**A66 Northern Trans-Pennine project
TR010062**

**8.1 Change Application –
Application Report**

24 March 2023

Planning Inspectorate Scheme Reference	TR010062
Application Document Reference	8.1
Author:	A66 Northern Trans-Pennine project, Project Team, National Highways

Figure DC-14(c) Before (left) & After (right) Extract from Traffic Regulation Measures (Speed Limits) Plans

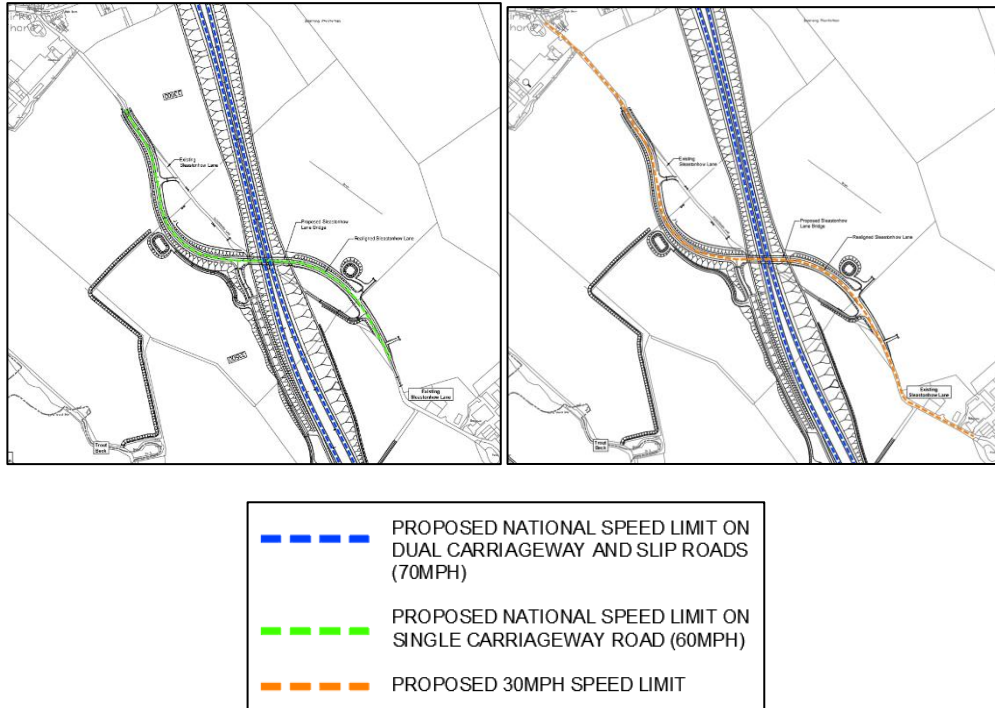
- 3.14.3. **Alignment/ Design Speed/ Speed Limit:** To achieve this change the design speed of the re-aligned Sleastonhow Lane is reduced to 30mph to allow for the road geometry to be changed while maintaining compliance with local highway design standards. Carriageway width to be 3.5m with passing places. To ensure the change is safe for all road users, a reduction in the speed limit to 30mph is required for the full length of the existing and diverted Sleastonhow Lane (from the existing 60mph speed limit, which is currently proposed in the DCO application).

Figure DC-14(e) Extract from Works Plan (After)

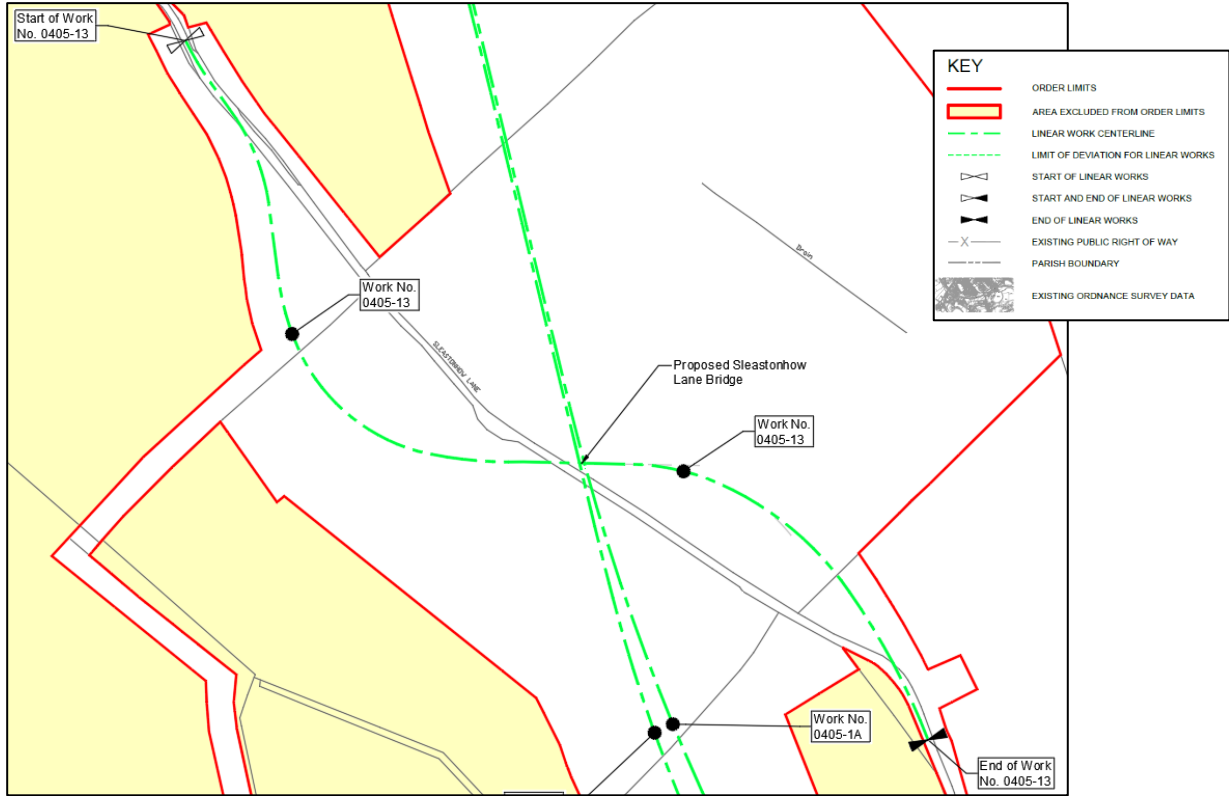
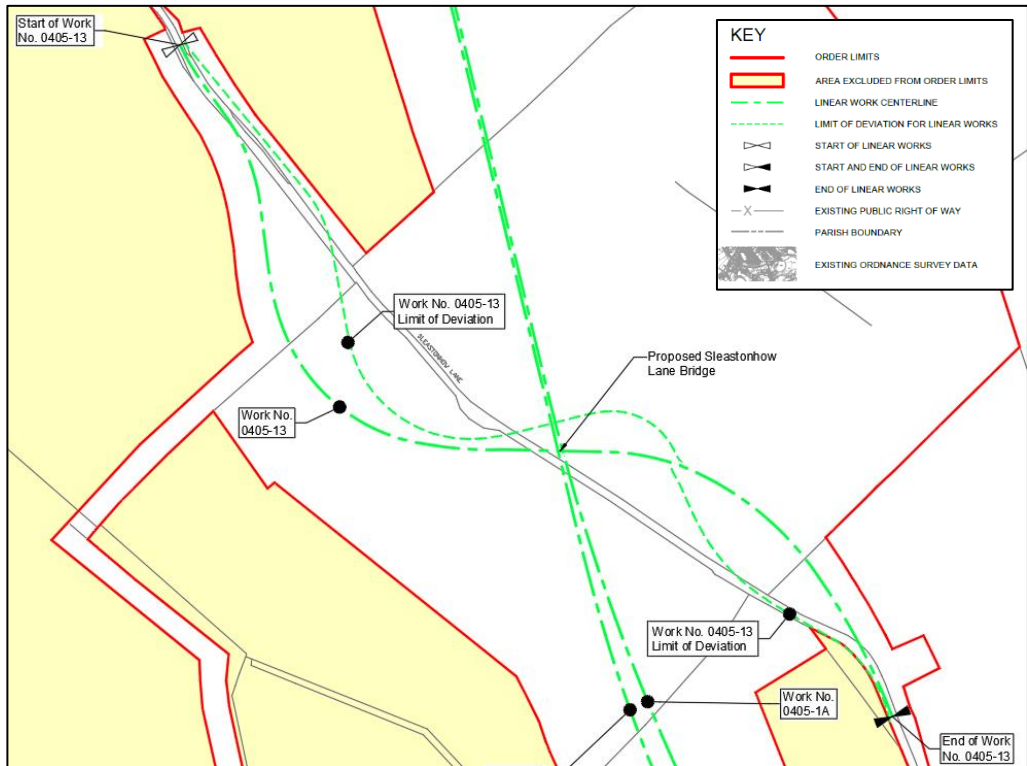
Work No.	Upwards vertical LoD	Downwards vertical LoD	Lateral/horizontal LoDs	Reason
0405-13	3m	To any extent the undertaker considers to be necessary to better follow existing ground levels	To the extent of the corresponding fine dashed green line shown on the works plans.	<p>Increased flexibility in horizontal to enable a squarer bridge crossing of the A66 mainline.</p> <p>Increase in the vertical so as to ensure that existing ground profiles can be followed.</p>

Figure DC-15(b) Extract from General Arrangement Drawing (After)

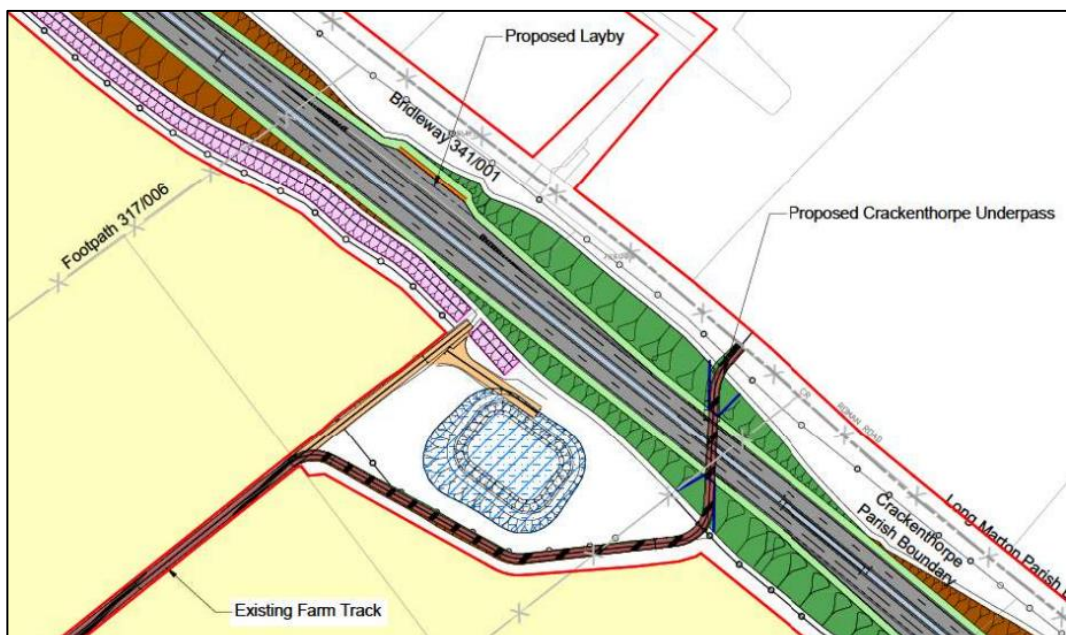
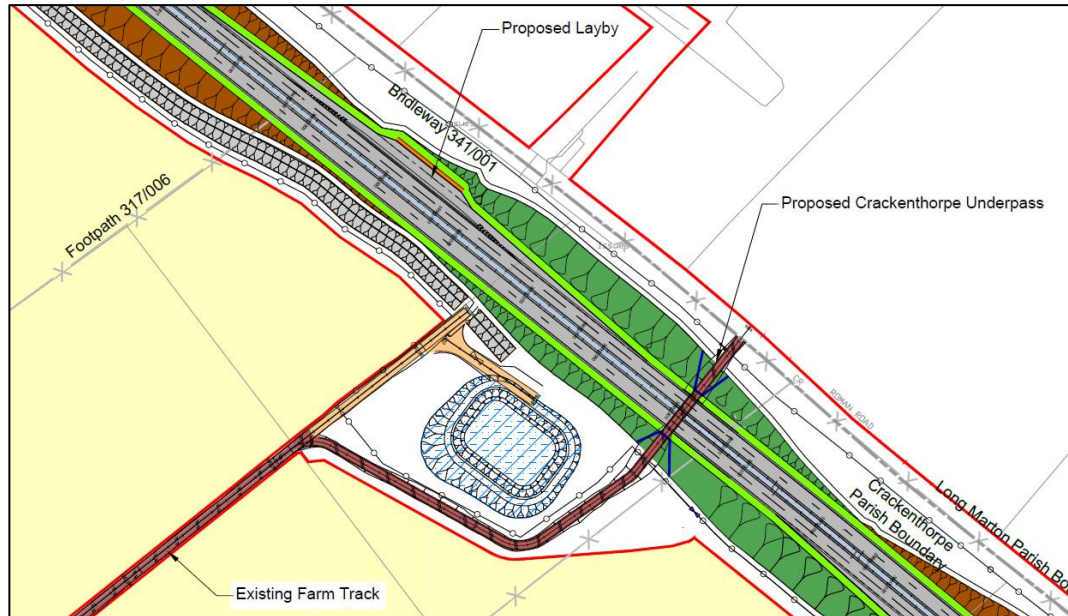
3.15.1. **Background to the Change:** The current DCO application proposes an underpass at Crackenthorpe for the use of a landowner to access their land and also to accommodate a diverted footpath and bridleway. The underpass was aligned with a natural valley to cross below the proposed dual carriageway at an angle that created a v-shaped route.

3.15.2. **Description of the Change:** A change is proposed to the LoDs associated with the underpass and the footpath, which would enable them to be aligned at a near right angle to the proposed dual carriageway, shortening the underpass and footpath.

Figure DC-15(d) Extract from Works Plan (After)

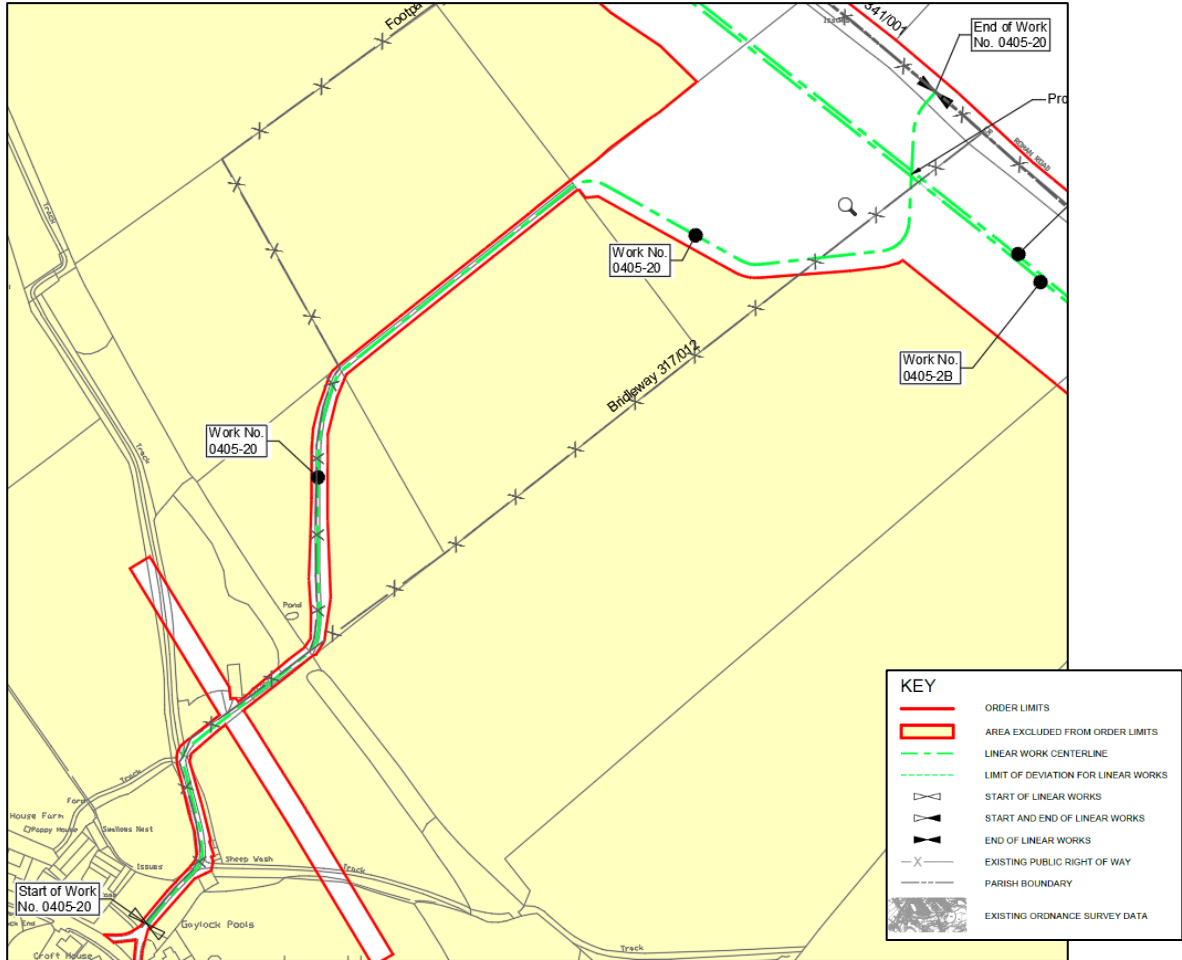
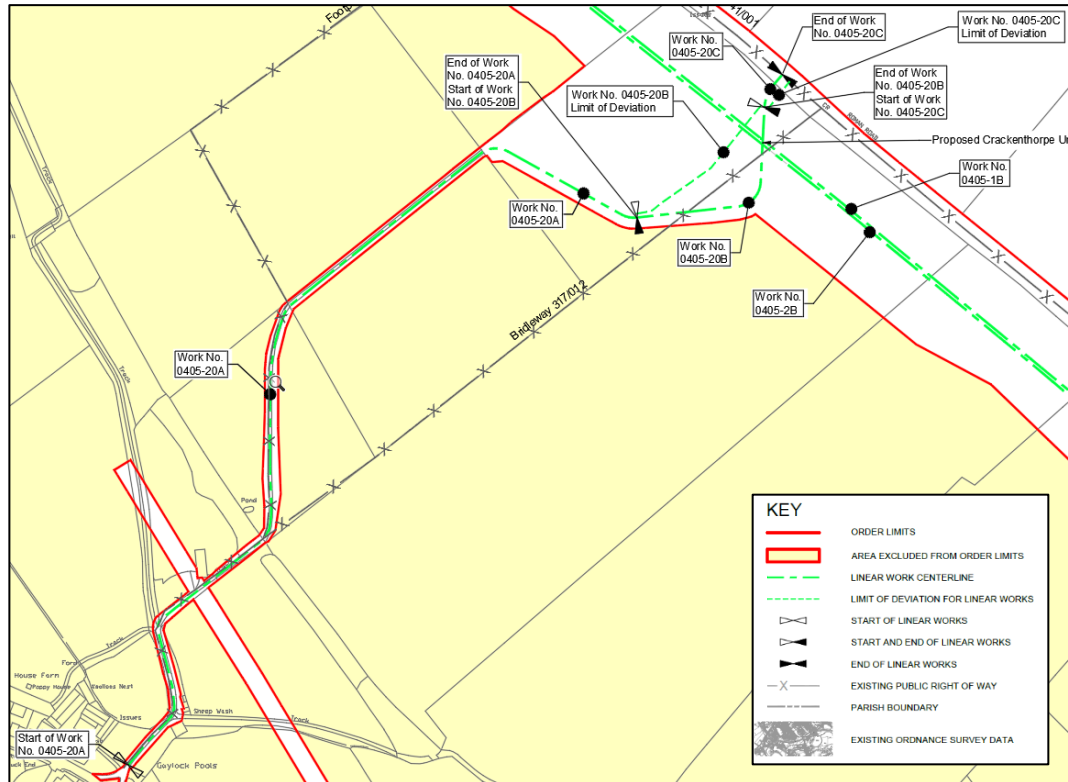
- 3.15.12. As outlined in Table DC-15(a), Work No. 0405-20 is to be split in to three parts to facilitate changes to the Crackenthorpe underpass. This will create Work No. 0405-20A, Work No. 0405-20B (at Ch0+180m) and Work No. 0405-20C (at Ch0+ 40m). The split Work No. 0405-20 is shown in Figure DC-15(d).

Figure DC-19(d) Extract from Traffic Regulation Measures Speed Limits Plans (After)

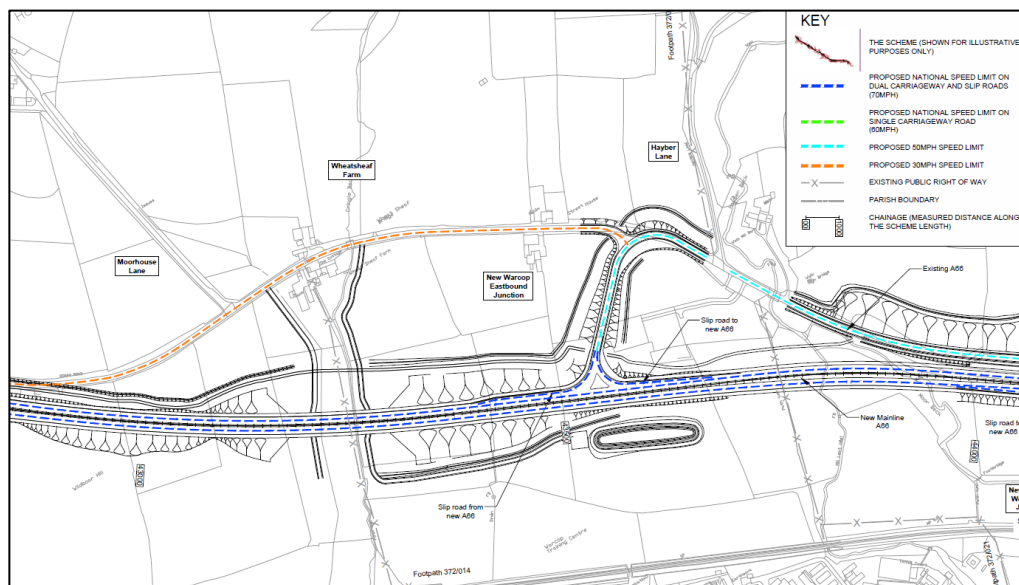
- 3.19.5. The design speed of the de-trunked A66 is reduced from national to 30mph by the change, making the route safer for all users (Refer to Figure DC-19(d)).

Figure DC-19(f) Extract from Rights of Way and Access Plans (After)

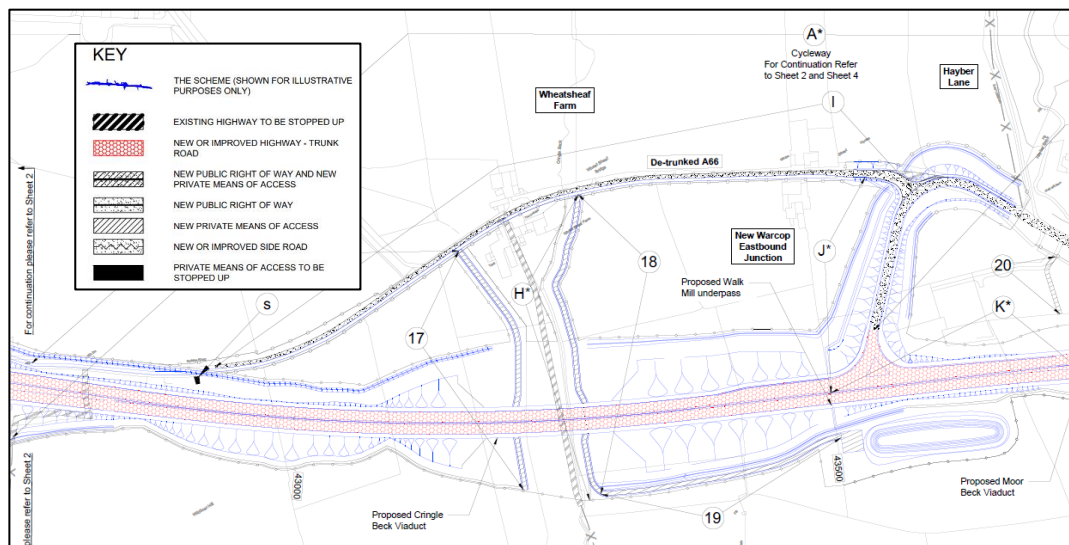
- 3.19.2. **Description of the change:** The change involves re-routing a small section of the walking and cycling route to move it away from the new A66 mainline and out of the floodplains of Moor Beck and Cringle Beck. The proposed route will utilise part of the old, de-trunked A66 road instead (Refer to Figure DC-19(b)). The old A66 carriageway will become a shared route providing access to properties as well as the walking and cycling route.

Figure DC-19(h) Land now required as a result of the proposed change, updated in response to landowner feedback

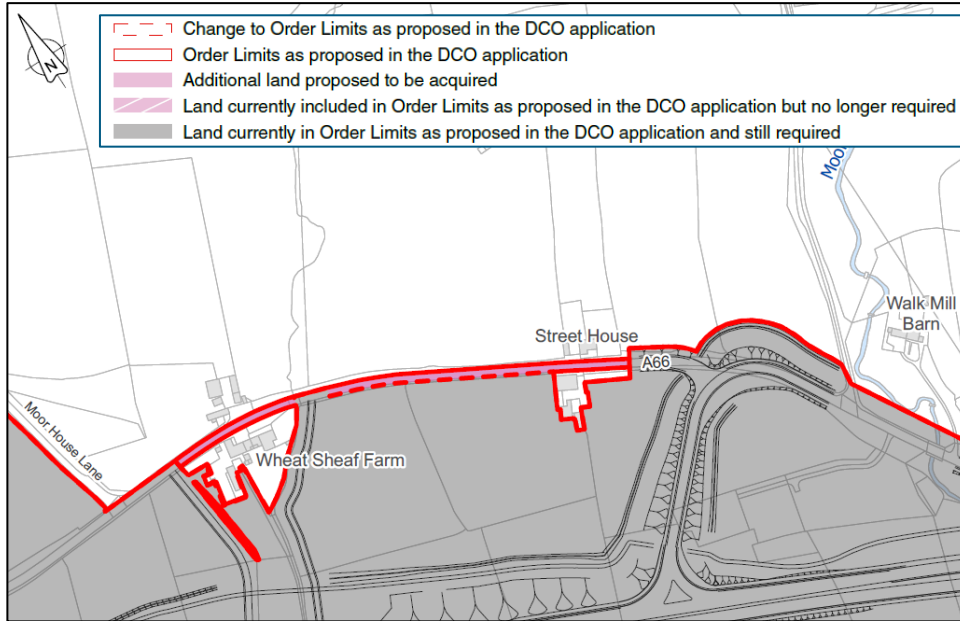
- 3.19.15. Refer to Figure DC-19(g) for the initial land requirement and to Figure DC-19(h) for the land requirement as amended in response to landowner feedback on this proposed change.

Figure DC-19(j) Extract from De-Trunking Plans (After)

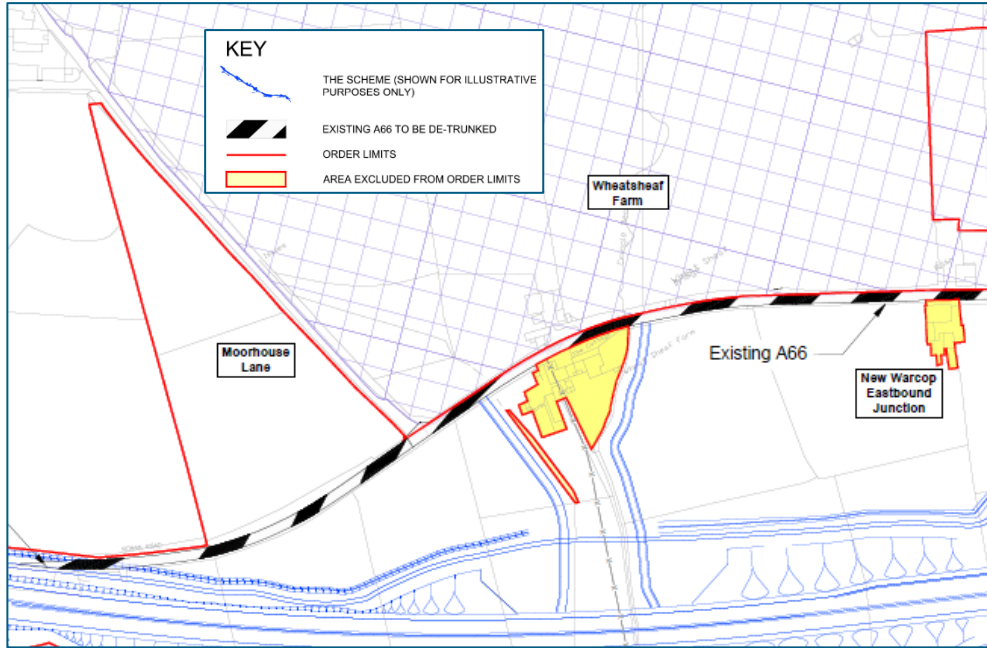
3.19.16. **De-trunking:** An area of highway, previously shown in the original submission to be stopped up, will now be retained and de-trunked to allow the new cycleway to be accommodated within the old A66 (Refer to Figure DC-19(i)).

Figure DC-19(I) Extract from Works Plans (After)

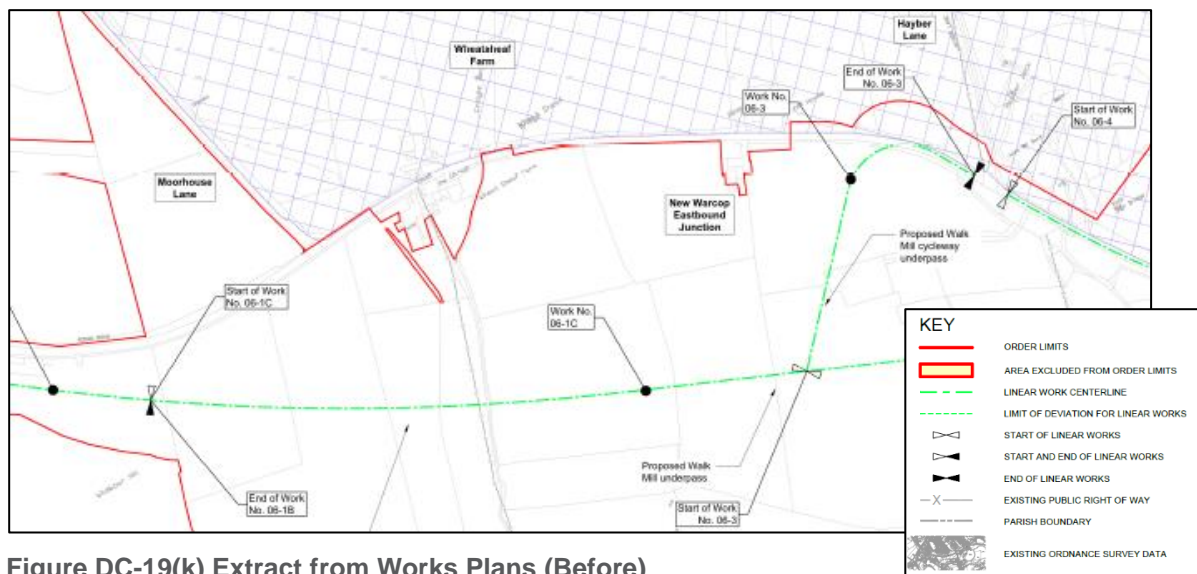
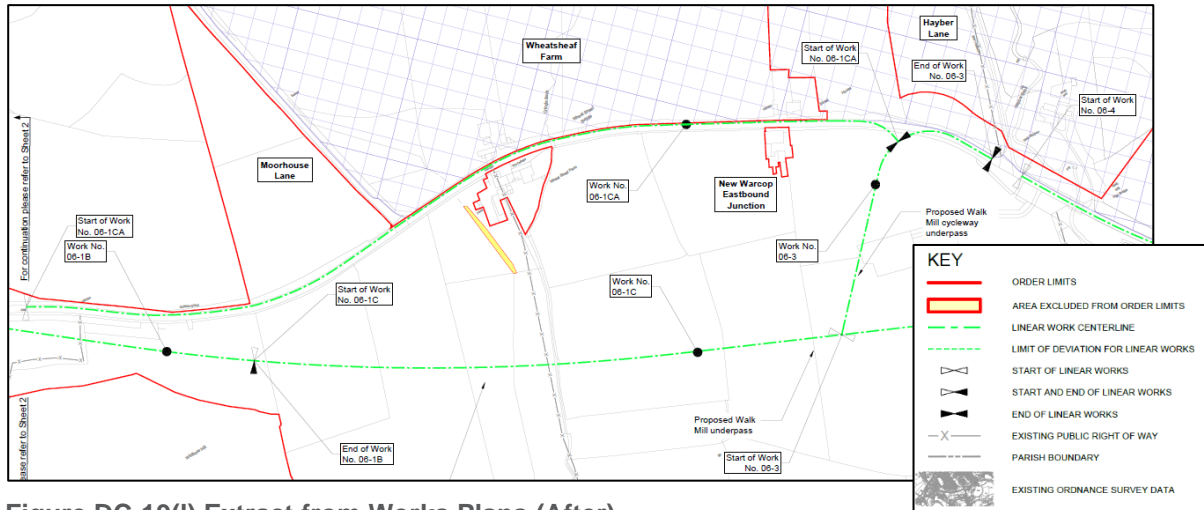
Works No.	Upwards vertical LoD	Downwards vertical LoD	Lateral/horizontal LoDs	Reason
06-1CA	Standard	Standard	Standard	New Work No to allow introduction of cycleway to be provided along the line of the existing A66 (which is outside of the highway boundary of the new A66)

Figure DC-21(a) Five geographical areas affected

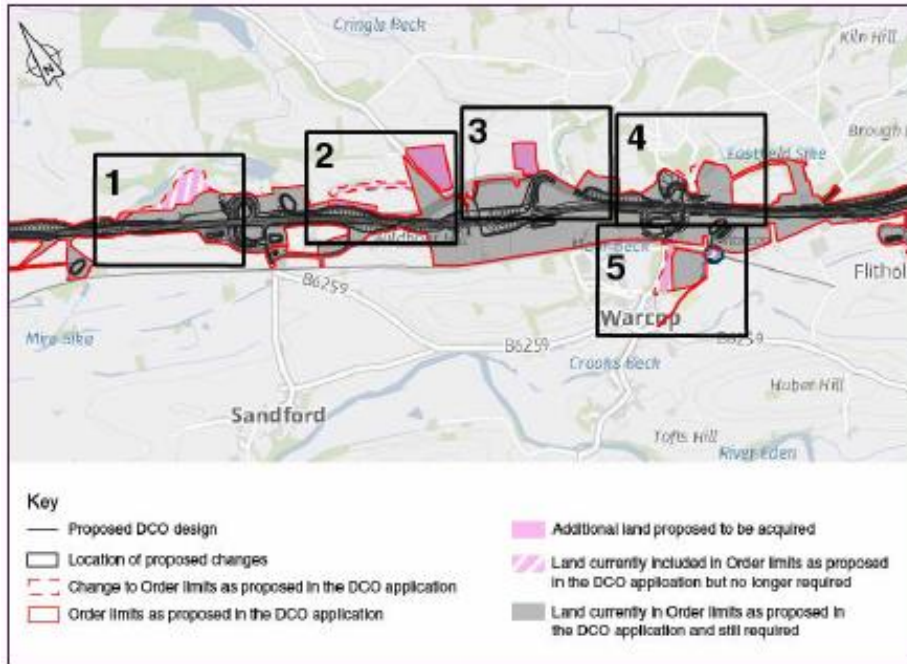
- 3.21.3. The Proposed Change has been split in to five geographical areas comprising one or more amendments as detailed below and as shown in overview in Figure DC-21(a).
